PRE-APPLICATION ADVICE LETTER

30 Fitzjohn's Avenue, NW3 5NB

The proposal is for the installation of a glazed balustrade on the second-floor flat roof to provide a roof terrace, including the replacement of a rear window with patio doors.

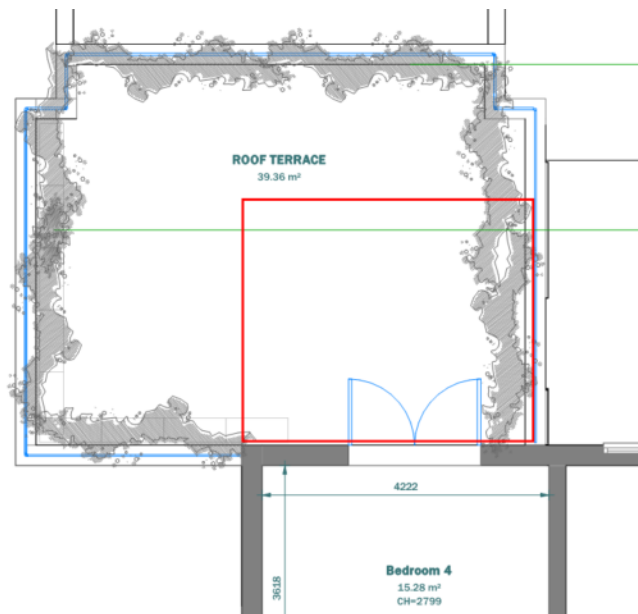
The proposed roof terrace includes the use of 1.7m tall obscure glazed balustrades along the north and south edges to reduce any overlooking or privacy impacts to neighbouring residential properties. Overall, the proposed roof terrace is not considered to lead to any impacts to neighbouring amenity with regards to daylight/sunlight, outlook, or privacy.

To reduce the need for privacy screening, the roof terrace could be scaled back, and area reduced (see Summary). This would eliminate the harm to the host building, as outlined in the design section, and allow for longer views from the terrace without any obstructions.

To alleviate the concerns outlined above, it is suggested that the roof terrace be reduced in size to occupy the area behind the rear flank wall of the fourth floor. The result is a roof terrace that is of sufficient size to provide outdoor amenity area for occupiers while reducing the impact on the host building and wider conservation area (see image below). As suggested above, the materiality of the balustrades should be reconsidered, and the use of metal or timber explored.
